## Peer Review File

Investigating microstructure evolution of lithium metal during plating and stripping via operando X-ray tomographic microscopy

## **A Point-by-Point Response to Reviewers (NCOMMS-22-17503-T)**

Supplementary Figure 2. Voltage profiles of consecutive plating/stripping cycles in operando cell. a, at 0.5 mA cm<sup>-2</sup>. b, at 1.0 mA cm<sup>-2</sup>.

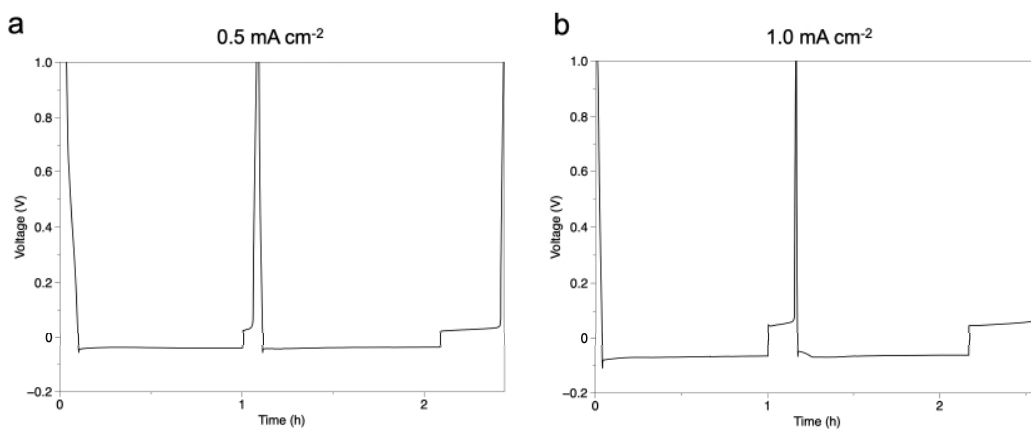
*2. The authors compared the morphology between 1st cycle and 2nd cycle. The authors then attribute the difference in morphology and voltage profile to the differing current densities. However, these data are insufficient to make this claim, as there are many variables that differ between the 1st and 2nd cycles (for example, the residual of SEI or Li dendrites after the 1st cycle, changes in the number of nucleation sites, etc.). I recommend that the authors conduct two experiments*

that run several cycles without changing the current density (one at 0.5 mA/cm<sup>2</sup>, the other at 1.0 mA/cm<sup>2</sup>) on separate samples.

**Authors' response:** We fully understand the concern of reviewer and it is the first question we faced when the experiment was designed. Both the cycling history and the current density will influence morphology of deposited Li and ideally one would like to disentangle the two effects. However, to follow the evolution of the microstructure it is central to actually compare the growth and dissolution of structures and quantitatively analyze the changes in exactly the same area/volume (like in Figures 3 and 5 in the revised manuscript). This is not possible if the tomograms are collected from two different cells. With regard to this, we have throughout the revised manuscript clarified that both the second cycle and a higher current density are factors influencing the nucleation and deposition process. In addition, we have added new experimental electrochemical data from two separate operando cells where electrochemical plating/stripping was performed at constant current densities (0.5 mAcm<sup>-2</sup> and 1.0 mA cm<sup>-2</sup>, respectively) for subsequent cycles. The voltage profiles of these two cells are shown in Supplementary Figure 2, see also below. The data shows that the voltage profile in the second cycle at high current density is indeed different from the behavior at lower current density. The two-step profile for nucleation is only observed under high current density, in which the local current density on the area of bare Cu (black area in Figure 5 in revised manuscript) is enhanced since part of Cu surface is covered by inactive Li created in the first cycle. This points to enhanced effects by current density. We have added a discussion on this on page 7 in the revised manuscript.

Supplementary Figure 2. Voltage profiles of consecutive plating/stripping cycles in operando cell. a, at  $0.5 \text{ mA cm}^{-2}$ . b, at  $1.0 \text{ mA cm}^{-2}$ .

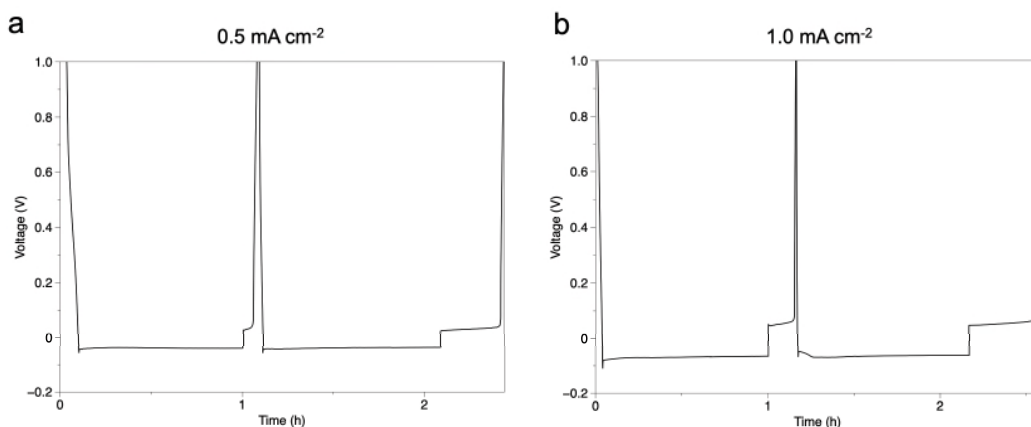
3. The voltage profile of Figure 2b: the lower overpotential at high current density may not be due to the current density. It may also be caused by the formation of some new nucleation sites or a change in the SEI layer after the 1st cycle or a decrease in the fresh exposed Cu surface in the 2nd cycle. Again, more data could sort this out.

**Authors' response:** We agree with the referee that there can also be other factors influencing the nucleation overpotential in the second cycle, as discussed above. From cycling of the operando cell offline (i.e. not during the tomography experiment) we can see that the overpotential at higher current density changes from first to second cycle which points to formation of new nucleation sites or change in SEI is indeed an important factor. We have added this to the discussion on the data in the revised manuscript on page 7 and also added the data with consecutive cycles at constant current density of the operando cell, Supplementary Figure 2 (see below), to underpin this result.

Figure 3 | Operando XTM during plating and stripping at different current densities.

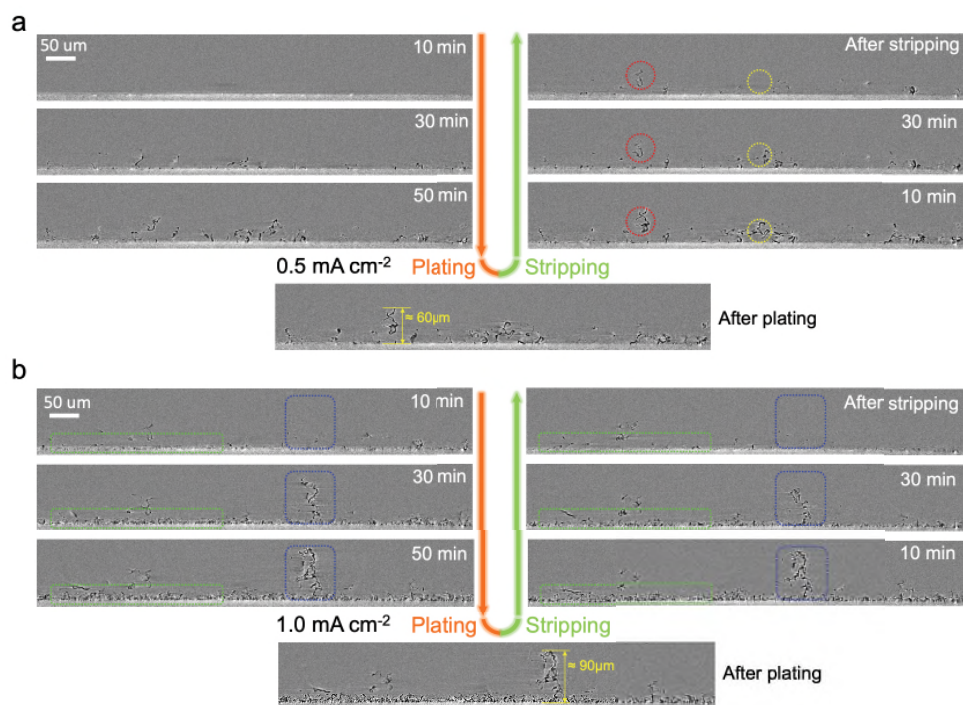
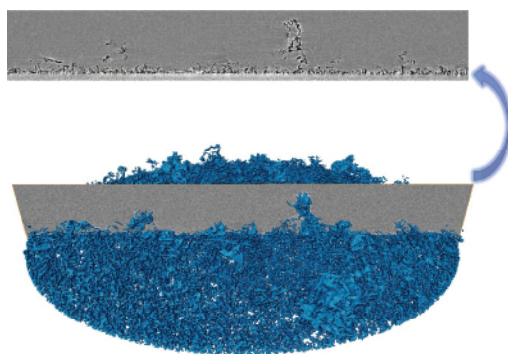
4. One question about Figure 2d and e: the last picture from the 1st cycle does not look similar to the 1st figure of the 2nd cycle. The inactive Li in Figure 2d (after stripping) is not seen in Figure 2e. If the images are not from the same spot, that needs to be mentioned. Additionally, I recommend the authors add a 3d rendering volume of Li dendrite in Figure 2 and mark the vertical slice where Figure 2d and 2e were taken.

**Authors' response:** The slices from the first and second cycle were indeed different, and we agree that this can cause confusion. In the revised manuscript, we have adjusted this and now all slices in Figure 3 on page 9 (previously in Figure 2) are taken from the same position in the 3D tomogram. The position is also marked in a 3D rendering of the data added as Supplementary Figure 5, please see also below. We have also clarified that the slices are from the same position in the 3D datasets on page 8.

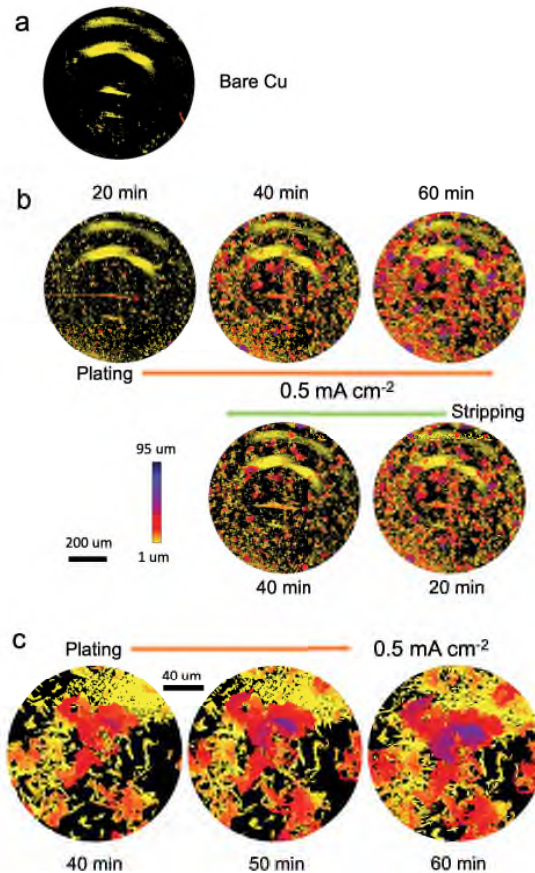
6. The authors propose in Fig. 3C that some Li becomes inactive during plating. Again, this may or may not be true - the evidence is not clear. This Li may become inactive quickly when stripping, but not during plating. If inactive Li is formed during plating, the evidence should be that Li dendrite stops growing at some point of time during the plating. More data is needed.

**Authors' response:** We understand the concern raised by the reviewer. Looking in detail into the heightmaps of Li deposited at  $0.5 \text{ mA cm}^{-2}$  for 40, 50, 60 minutes and after plating one can see that part of the Li microstructures already exists on the height map after 50 minutes plating and barely shows any change after that during plating, neither during stripping. This suggests that the disconnection of deposited Li from the electronically conductive network may occur at the early stage of stripping, or even during the plating. We have clarified this in the discussion on the data in the revised manuscript on page 11. We have also added the time series of the close-up region, marked with white circle (i) in Figure 5, as Supplementary Figure 8c.

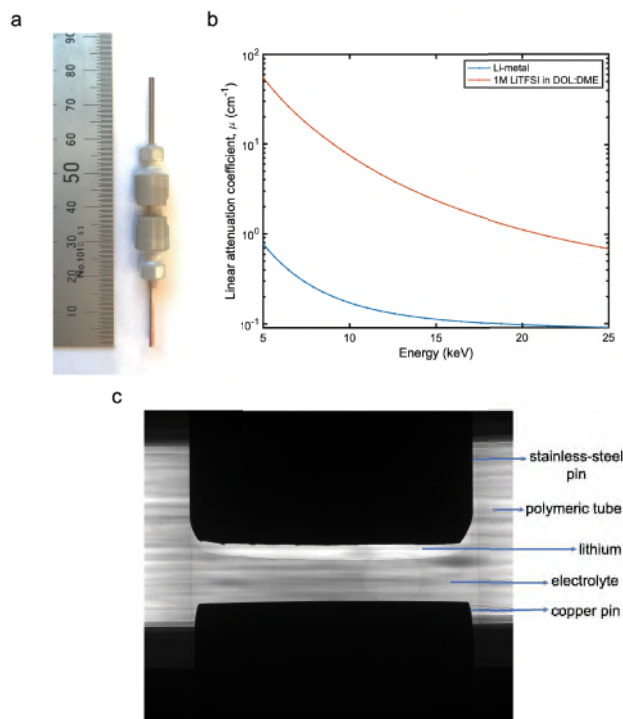
*1, The Li dendrites presented in the current work attract the reviewer's attention. As we all know, the contrast between Li (either pure Li bulk or electrochemically formed Li microstructures) and the electrolyte is poor. If there were no changes occurring at the Li/liquid electrolyte interface, we may probably have no idea which part is which, as the first panel in Fig. 2d shows. During electrochemical plating, changes occurred at Li/electrolyte interface, as shown in Fig. 2d. The authors assigned the black/dark regions to the electrochemically formed Li and the gray domain to the liquid electrolyte. This assignment, however, seems to be, some sort of, lacking of strong evidence for the following reason. The reason is that the authors didn't present the CT results of the Li metal adhered to the stainless steel pin. With this Li metal "reference" missing, it is hard to compare the electrochemically formed Li with the used Li metal "reference" so that one may not know the general X-ray absorption or contrast of the electrochemically formed Li. Can the authors present the CT results containing the Li metal? By the way, what is the distance between the Li metal and the Cu pin? The reviewer noted that the width of the FOV is  $0.8 \text{ mm}$ , which is smaller than the diameter of the Cu pin ( $\sim 1.58 \text{ mm}$ ). I am wondering, if the authors can provide the view that contains the side boundary of the Cu pin so that we can have a better idea of the distribution of the liquid electrolyte so that we can know the difference between the region where the Li microstructures are generated (in the presented images) and where the region no Li microstructures are generated? The reason I am asking is that, it seems to the reviewer that the black/dark regions in Fig.2 are, sort of voids that are formed after Li is electrochemically dissolved if we didn't take the electrochemical cycling into consideration.*

**Authors' response:** Distinguishing deposited Li is indeed challenging, but possible as shown by our work. In the experiment we deposit Li on the Cu-pin, thus we are looking at growth of structures at the Cu/liquid electrolyte interface (not Li/liquid electrolyte interface). In fact, there is considerable contrast between these components. One way of assessing this is through the linear attenuation coefficients of X-rays for Li and electrolyte which is shown as a function of wavelength in the figure below, calculated using the database of National Institute of Standards and Technology. At the X-ray energy of the experiment (18 keV) there is more than an order of magnitude difference in the linear attenuation coefficient, with Li-metal having lower attenuation compared to the electrolyte ( $0.102 \text{ cm}^{-1}$  and  $1.464 \text{ cm}^{-1}$ , respectively). This is a comparatively good contrast for X-ray imaging. Note that the attenuation of Cu is very much higher and not at all on this scale. Thus, in an absorption image Cu will be black, electrolyte grey and Li almost white. In the figure below we also show a projection of the cell acquired at low magnification (4x objective, this was done only for purpose of alignment and no tomograms were taken, thus the lower quality of this image) where both the steel pin with Li and the lower Cu pin are visible. In this image one can clearly distinguish the light-colored Li from the electrolyte (grey) and the Cu and steel pins (black). Note that in Figure 3 (previous Figure 2) Li appears as black since the color scales are inverted in the segmentation process. We have added information on the linear attenuation coefficient and the projection of the cell at lower resolution to supporting information, Supplementary Figure 1. In addition, we have added a step by step description on the segmentation of Li in the tomograms in supporting information as Supplementary Figures 13-21.

The distance between the stainless-steel pin and the Cu pin was 2 mm. Thus, when using the high resolution (a  $0.33 \text{ }\mu\text{m}$  voxel size, 20x objective) to acquire the operando X-ray tomograms, the Li metal adhered to the stainless-steel pin is out of the field of view. In the operando experiments the field of view is 0.8 mm and the cell was not moved in order be able to track the growth of Li structures. Thus, we do not have data showing the boundaries of the Cu pin at these conditions. However, the electrolyte was distributed throughout the cell.

Figure 3 | Operando XTM during plating and stripping at different current densities.

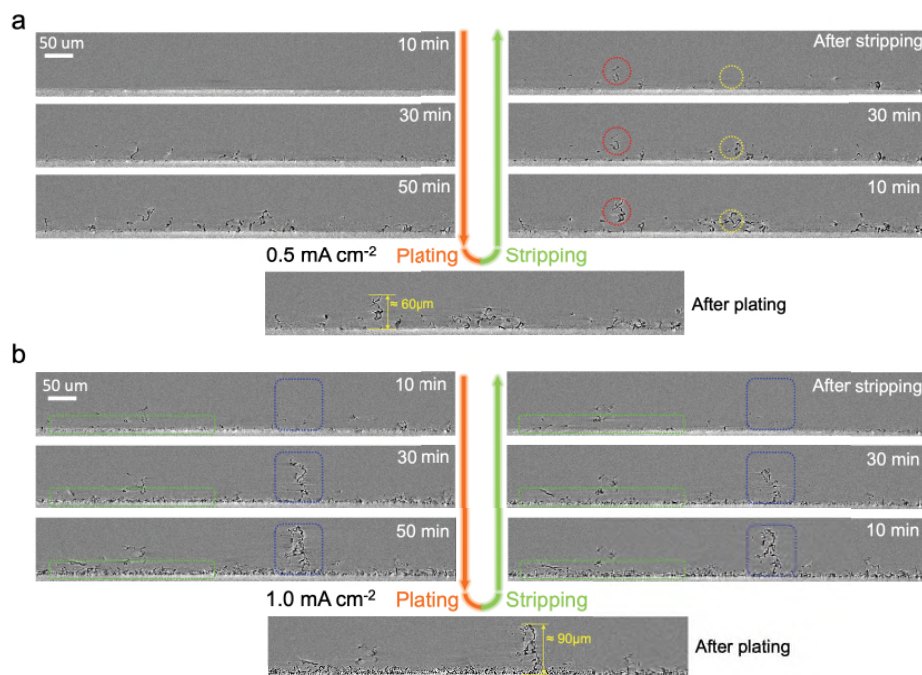
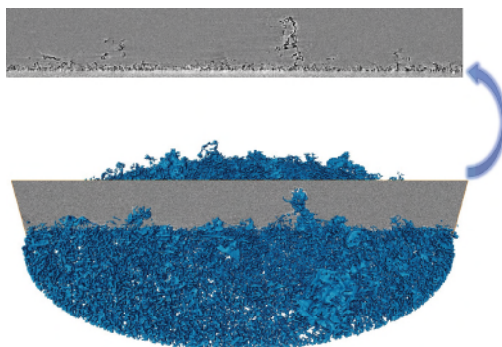
3, The regions presented in Figure 2d and Figure 2e are not the same, right? I think it's better to make this clear to the reader.

**Authors' response:** The slices from the first and second cycle were indeed different, and we agree that this can cause confusion. In the revised manuscript, we have adjusted this and now all slices in Figure 3 on page 9 (previously in Figure 2) are taken from the same position in the 3D tomogram. The position is also marked in a 3D rendering of the data added as Supplementary Figure 5, please see also below. We have also clarified that the slices are from the same position in the 3D datasets on page 8.

Figure 5 | Height maps of deposited Li at different stages of plating and stripping.

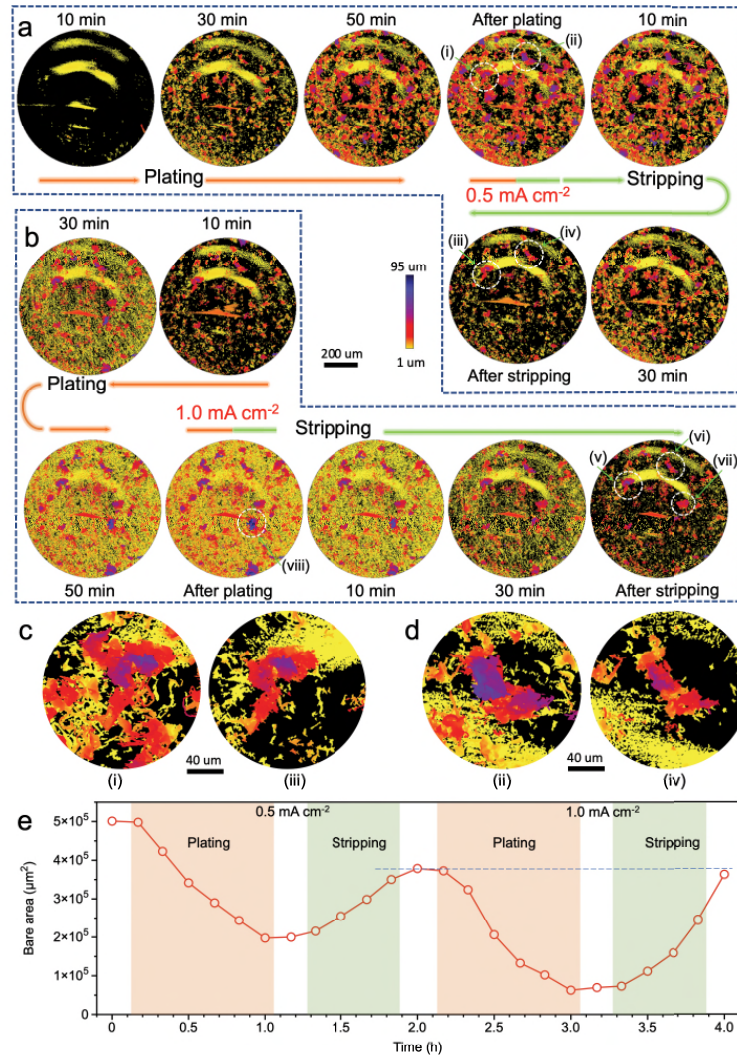
4, The descriptions of the white circles in Figure 3 are not specific and hard to comprehend. On the one hand, the authors highlight two regions in Figure 3a by using two white circles, which are enlarged and shown in Figure 3c and 3d, respectively (it is suggested to mark c,d in the circles in Figure 3a). on the other hand, there are two circles again presented in Figure 3c. But these two circles are marked for different stories, right? Overall, the notations are not logically presented and the corresponding text descriptions are unpleasantly written. This makes the readers hard to understand and follow.

6, The colour legend in Figure 3 needs to be changed. If I understand correctly, the dark area in the tomograms are bare Cu, right, which is the lowest height. However, from the colour legend, the dark colour represents the highest, which is 100  $\mu\text{m}$  high.

7, The reviewer can't get the point in Figure 3e where "the amounts of bare area at the same deposition capacity (0.5 mA cm<sup>-1</sup> for 1h, 1.0 mA cm<sup>-1</sup> for 0.5h, connected by dashed line in Fig. 3e) are very similar, although the architecture of deposited Li (after 1h plating in Fig. 3a and 30 min plating in Fig. 3b) under the two current densities are quite different." What is the message that the authors want to convey?

**Authors' response:** To improve the readability and the presentation of the data in previous Figure 3 (now Figure 5) we have added Roman numbers for each highlighted region, which are also then referred to in the text. The corresponding numbers of notations are added in the revised manuscript, please see pages 11 to 13.

**Authors' response:** We understand the problem with the color scale in the figure. The black area in the tomograms is bare Cu whereas the highest Li microstructures in fact are dark blue. The color legend is defined by AVIZO and the color legend in use shows the best presentation. To avoid misunderstanding of the color legend we cut it to 95  $\mu\text{m}$  and there is no very dark blue region left there, see Figure 5 (previous Figure 3).

**Authors' response:** The point was to emphasize that the amount of bare area is related to the capacity of deposited Li rather than the architecture. However, we see that this discussion is not adding anything, and we have therefore removed this sentence in the revised manuscript and revised the figure by removing that dashed line, see page 14.

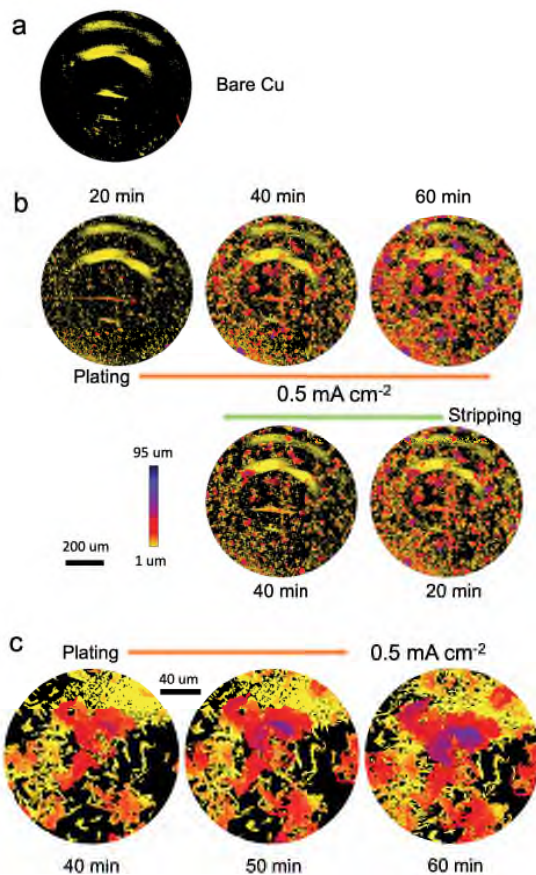
5, Can't understand the statement on page 8 that "the formation of inactive Li during plating". It is generally widely accepted that the inactive Li become distinguishable during Li stripping process because the inactive Li are not strippable

and they remain during stripping process. As a result, we can confirmatively state the remained Li after stripping are inactive Li. However, during plating process with a lot of Li microstructures generated, it is hard to tell which part, if there are, of the Li microstructures are inactive.

**Authors' response:** We understand the concern raised by the reviewer. Looking in detail into the heightmaps of Li deposited at  $0.5 \text{ mA cm}^{-2}$  for 40, 50, 60 minutes and after plating one can see that part of the high Li microstructures (blue pixels) already exists on the height map after 50 minutes plating and barely shows any change after that during plating, neither during stripping. This suggests that the disconnection of deposited Li from the electronically conductive network may occur at the early stage of stripping, or even during the plating. We have clarified this in the discussion on the data in the revised manuscript on page 11. We have also added the time series of the close-up region, marked with white circle (i) in Figure 5, as Supplementary Figure 8c.

Figure 3 | Operando XTM during plating and stripping at different current densities.

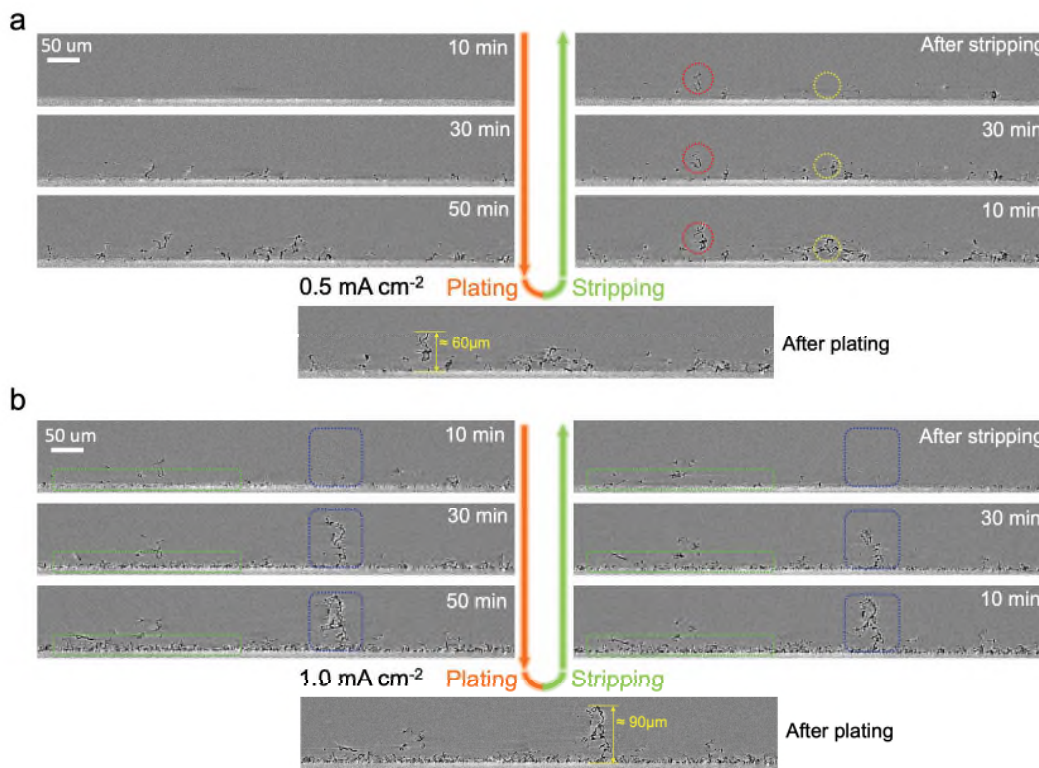
*This paper is written well, and all conclusions are supported by the data. Figure 2 needs additional markers and its discussion should be revised to make it clear what area in Fig 2 is being discussed. Fig. 2 shows several regions of interest- one area was highlighted in yellow circle, another in red oval, and third was marked with green rectangle. In some places authors referred to specific area and how it was marked, but in some places, they referred to area without indicated how it was marked (for example green area). Also, there was additional area of interest discussed, with mossy and needle-like structure, but the area is not marked in the Fig 2.*

**Authors' response:** To increase the readability of the discussion of figure 2 (figure 3 in the revised manuscript) the highlighted regions on vertical slices are explicitly referred to in the text on page 8 to page 10 and all specific regions discussed are now marked.
